Central Zoo Authority

Sub:- Amended designs for the construction of various enclosures at Jaipur Zoo, Jaipur.

Ref:- Your office letter No. 5388 dated 06.09.2012.

The amended designs for the construction of various enclosures at Jaipur Zoo, Jaipur were placed before the Expert Group of Zoo Designing Meeting held on 20th September 2012. The members scrutinized the designs and following observations were made:-

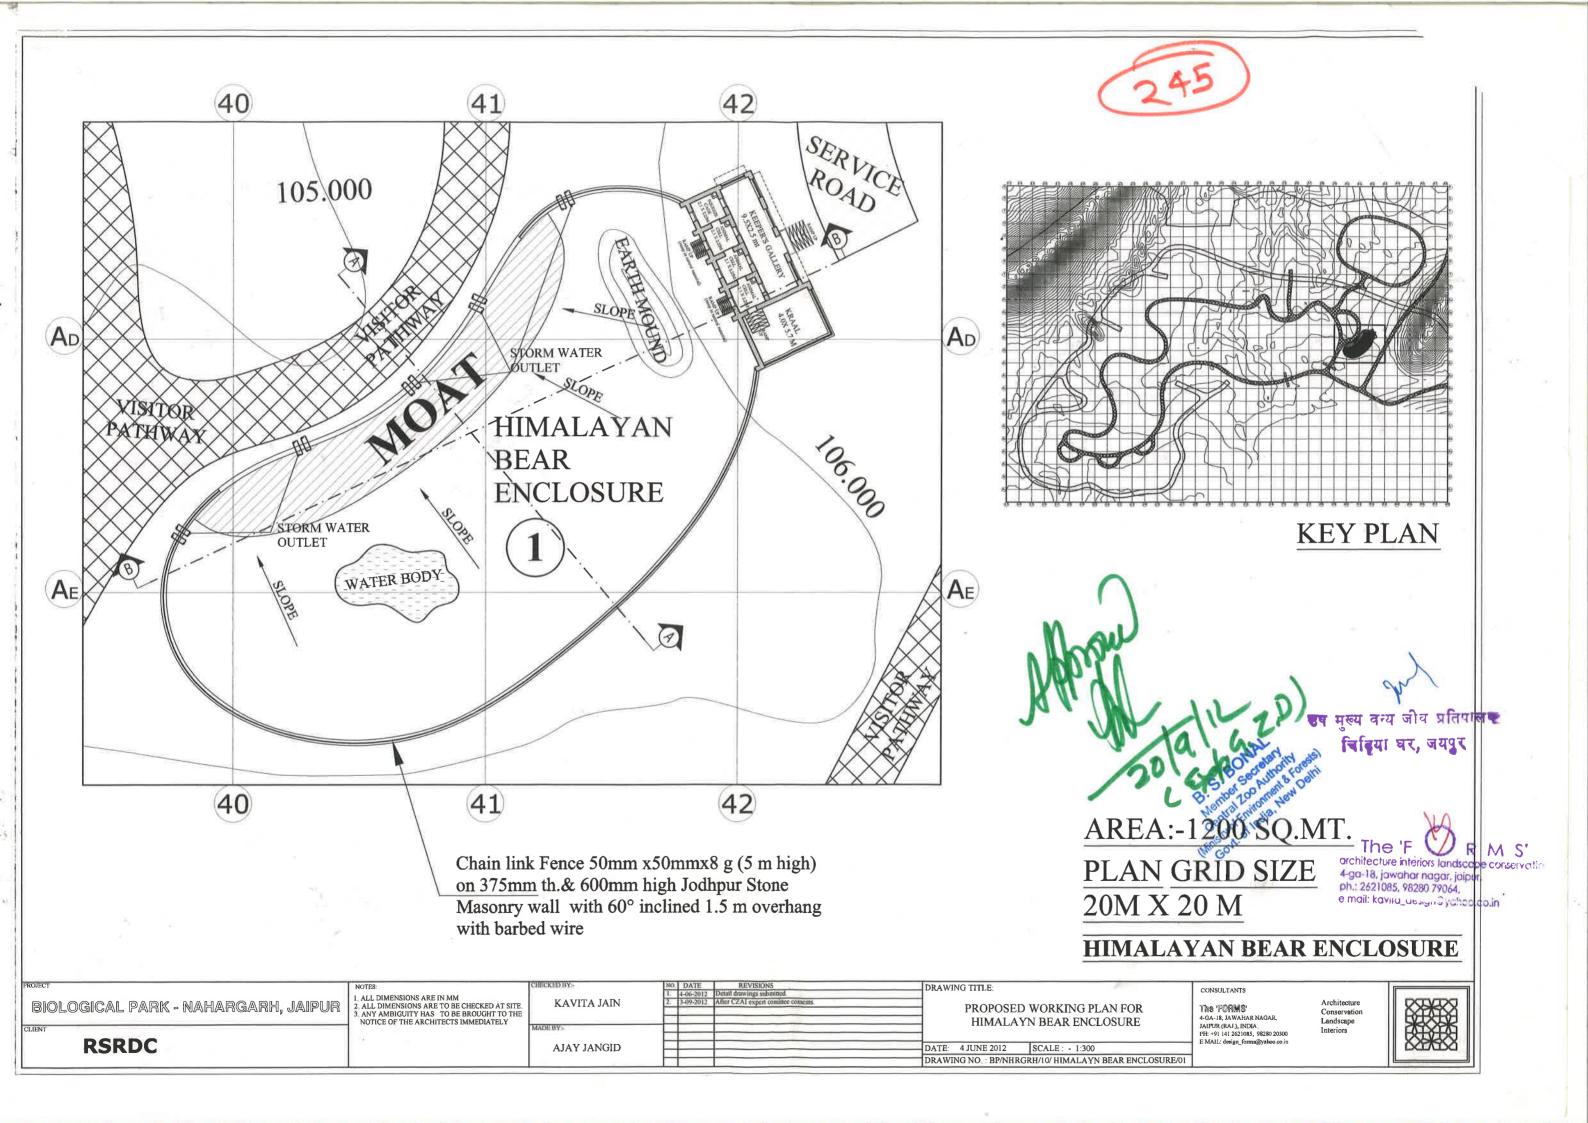
(i) Construction of Himalayan Black bear enclosure

The design was scrutinized and approved. (signed copy enclosed)

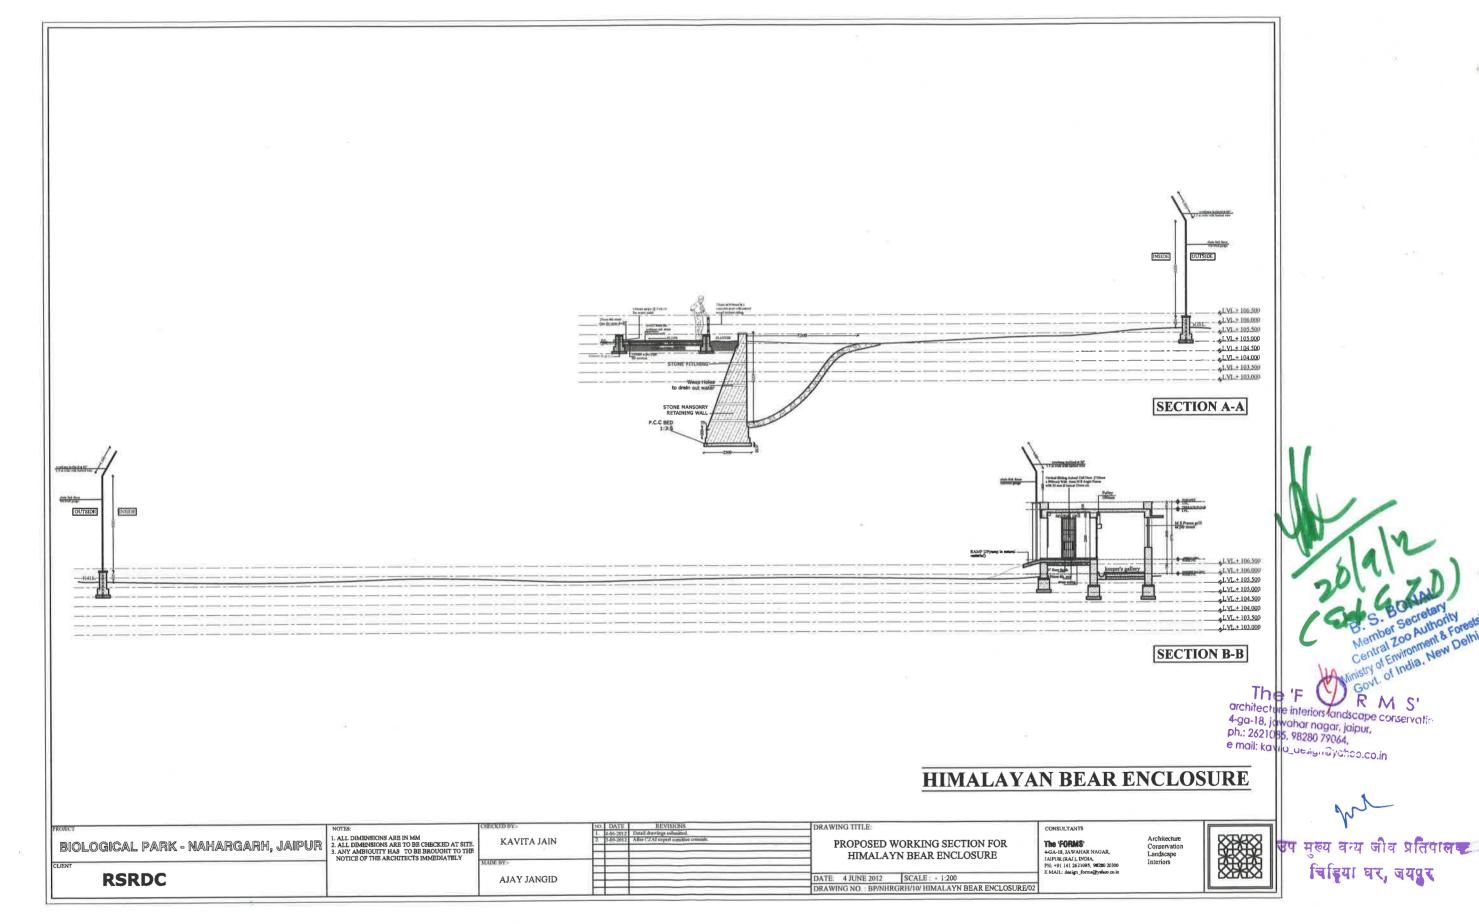
(ii) Construction of Sloth bear enclosure

The design was scrutinized and approved. (signed copy enclosed)
